SUBJECT: TRAFFIC METHODOLOGY APPROVAL LETTER
PROJECT NAME: ENCLAVE HOUSING CR 42 TRAFFIC IMPACT STUDY
PROJECT #2025010062 APPLICATION: #32409 PARCEL #47667-004-00

Project: Enclave Housing CR 42

Subject: Proposed Methodology for Enclave Housing CR 42

RE: Enclave Housing CR 42 Response to Comments

Figure 2. Project Trip Distribution

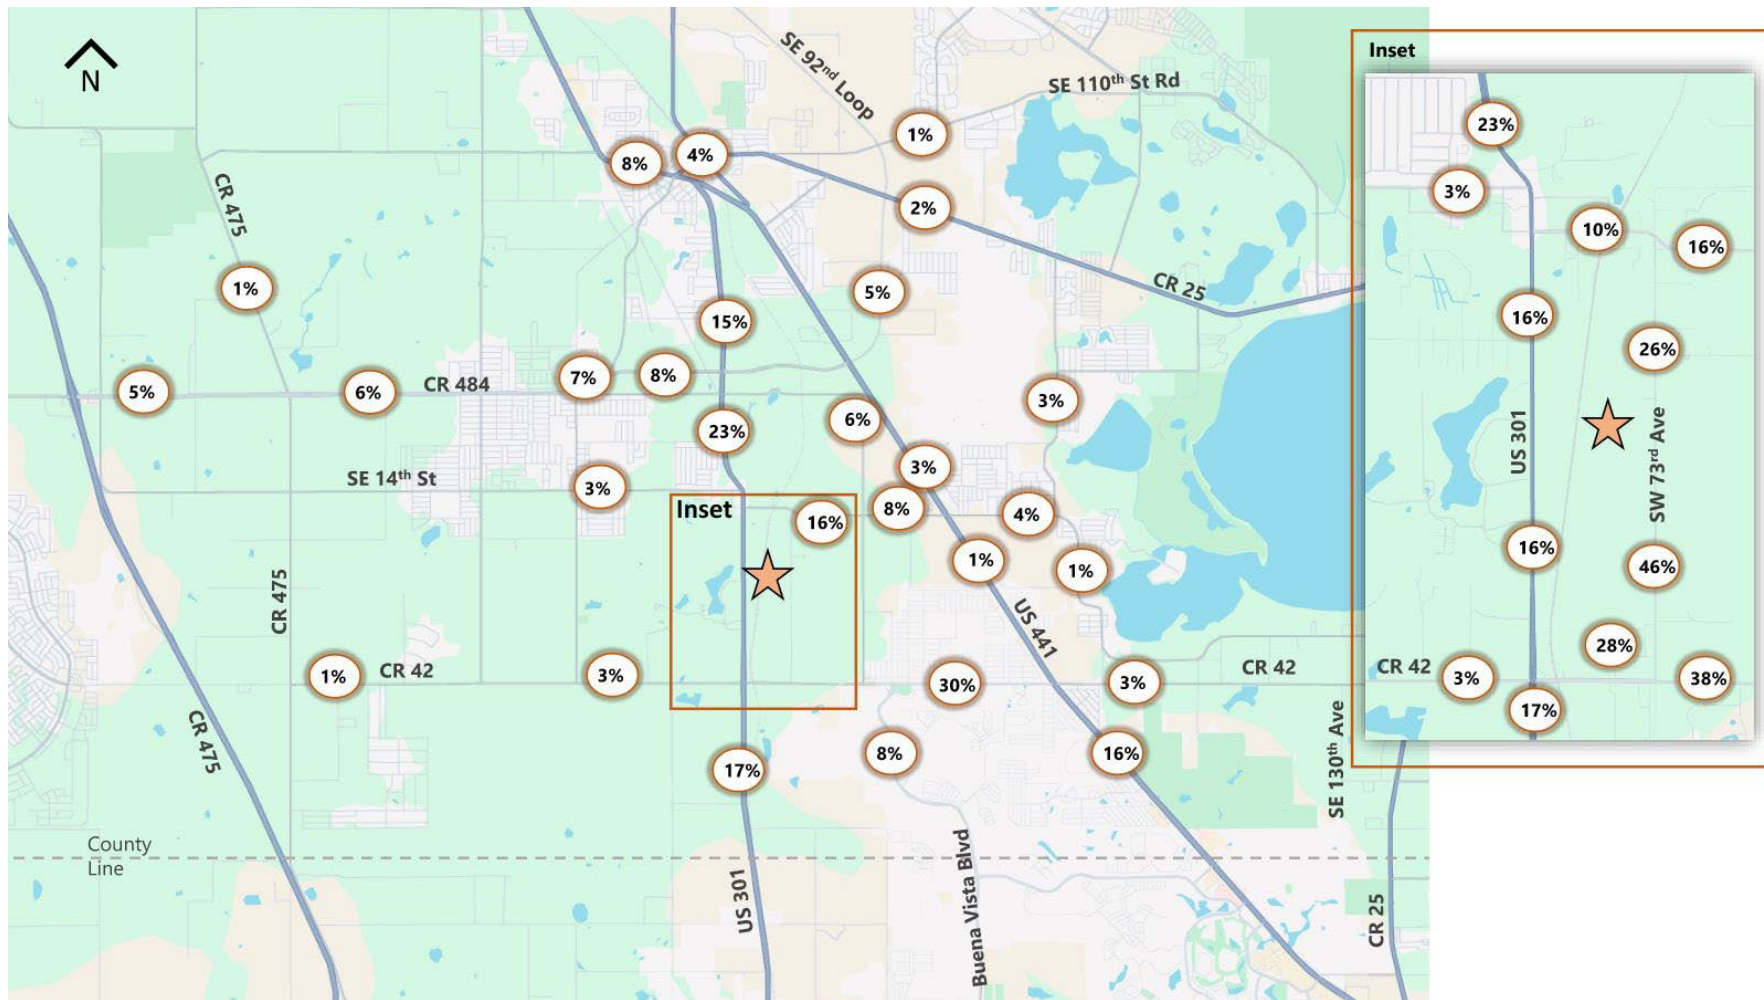
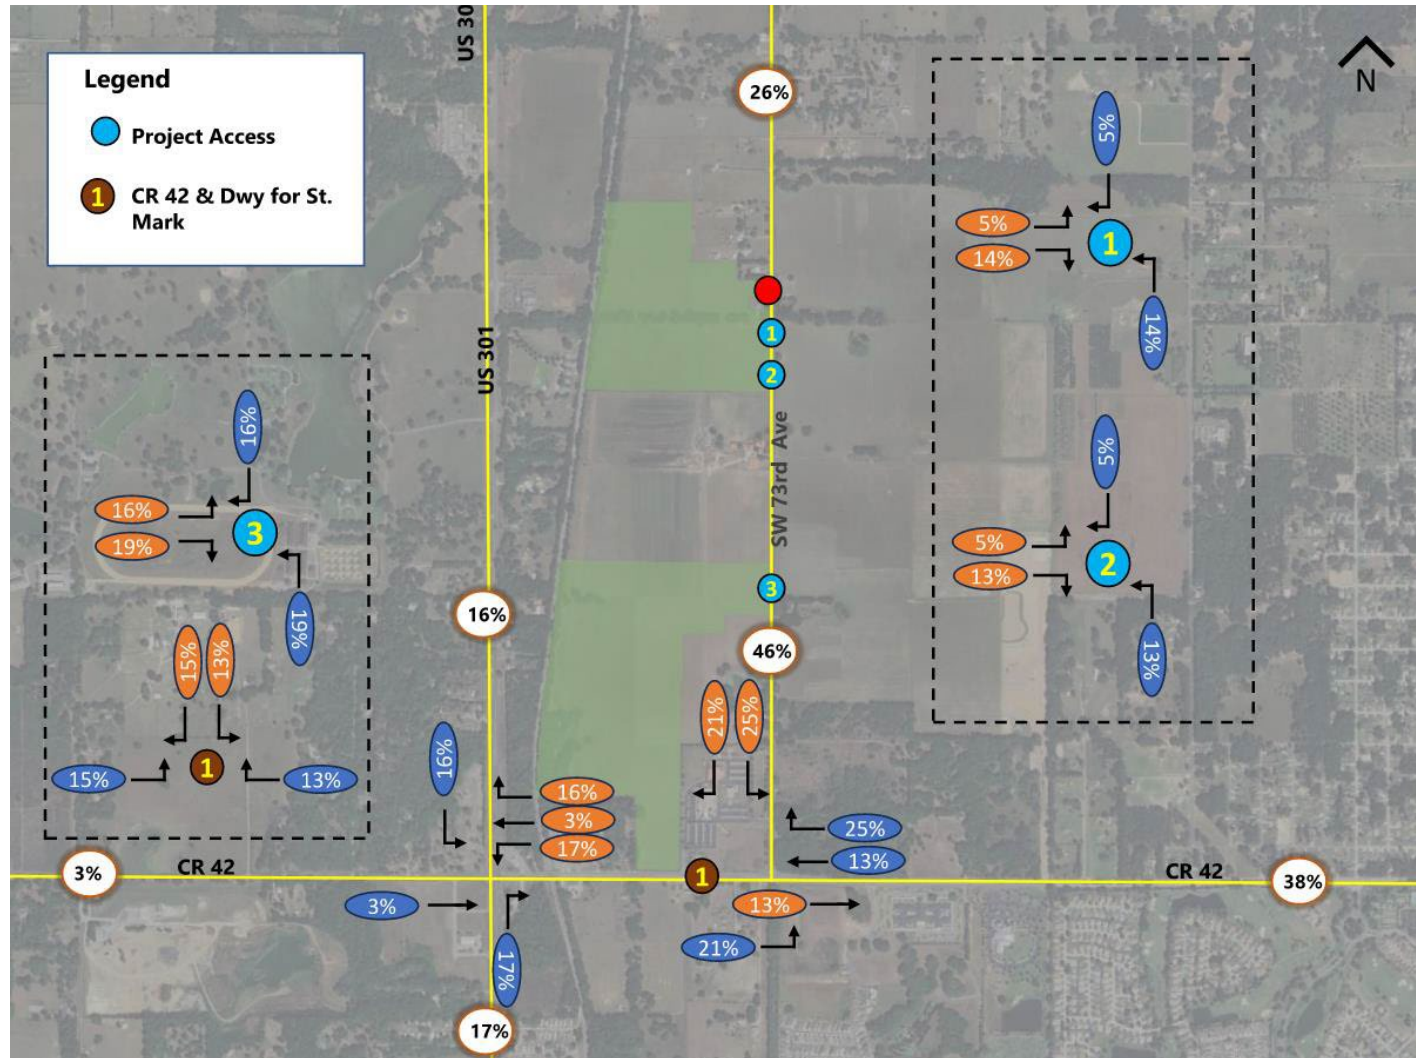
2. PDF pg. 4 & 5, Figures 2 & 3 - Figures 2 & 3 show different distributions to/from the south on SE 73rd Ave. Figure 2 shows 54% while Figure 3 shows 39%. Update the figures to show the same distributions on SE 73rd Ave. Ensure the distributions used in Table 2 also match the distributions shown on Figures 2 & 3.

Response: Agreed, and Figures 2 & 3 are updated accordingly.

Figure 3. Project Trip Distribution at Project Driveways

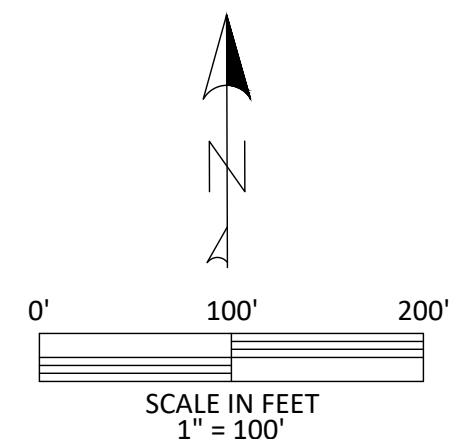
4. PDF pg. 5, Figure 3 - The 39% to/from the south on SE 73rd Ave needs to be changed to 46% based on the distributions shown at the driveways on SE 73rd Ave

5. PDF pg. 5, Figure 3 - The 15% of eastbound through traffic on CR 42 at SE 73rd Ave needs to be changed to 13%.

Response: Figure 3 has been updated to show 46% to/from the south on SE 73rd Ave.

Response: Figure 3 has been updated to show 13% eastbound through traffic on CR 42 at SE 73rd Avenue.

SITE DATA

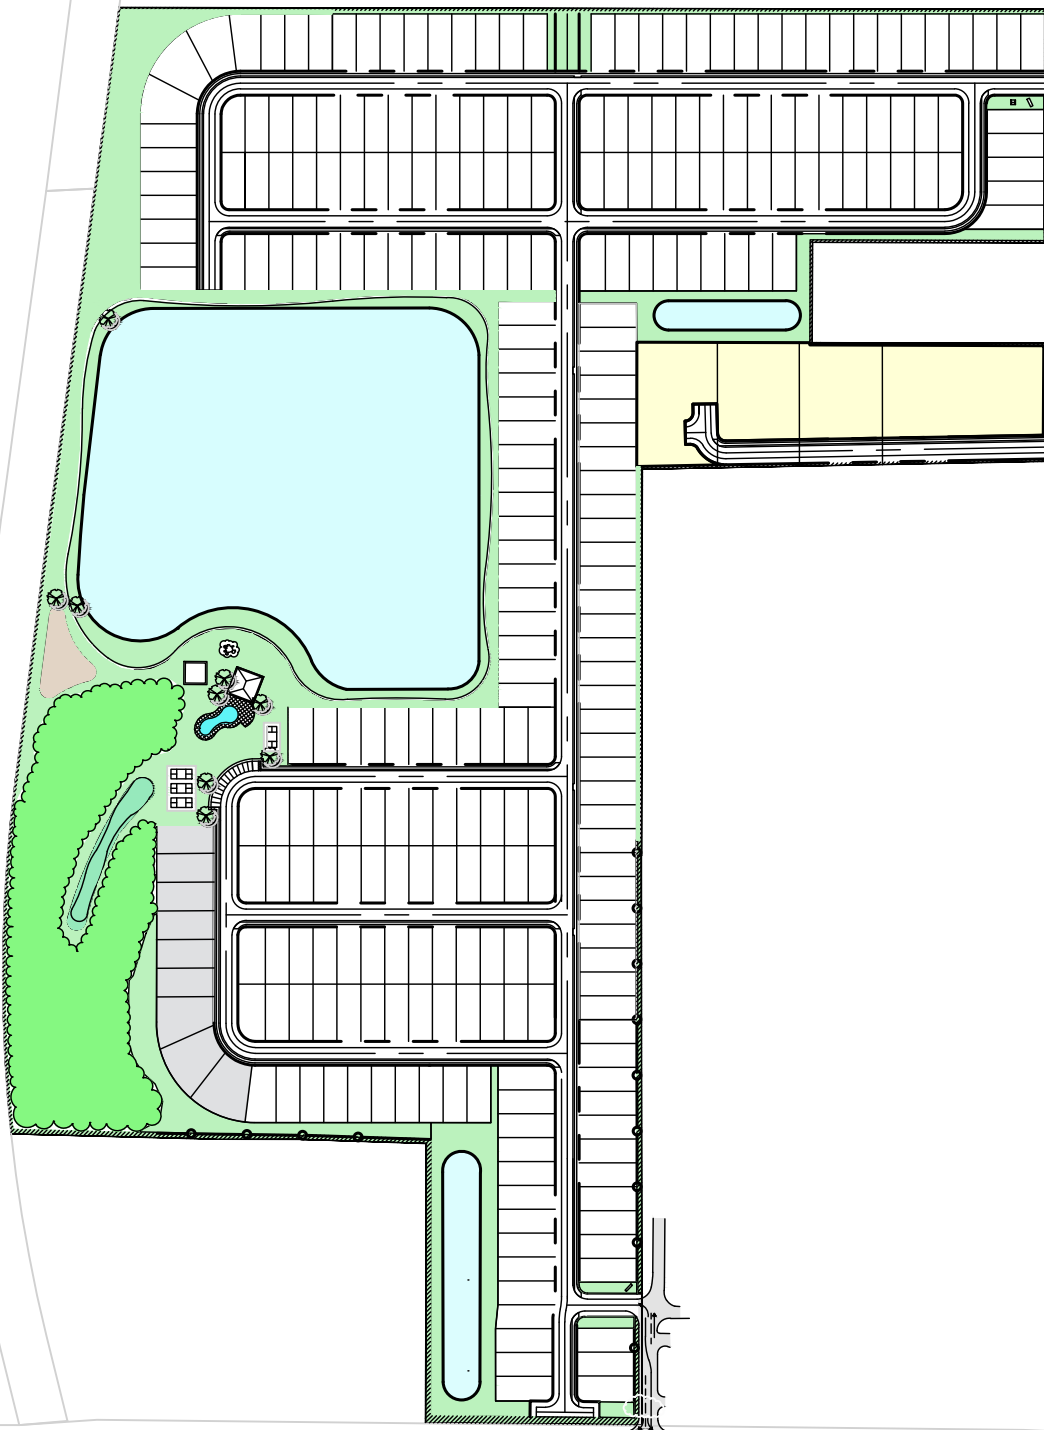
6. PDF pg. 12 & 13 - The site data shows the number of units proposed but does not show the proposed access locations. Provide an updated concept plan showing the proposed access locations on CR 42 and SE 73rd Ave.

Response: The concept plan showing the access locations is attached to the revised methodology.
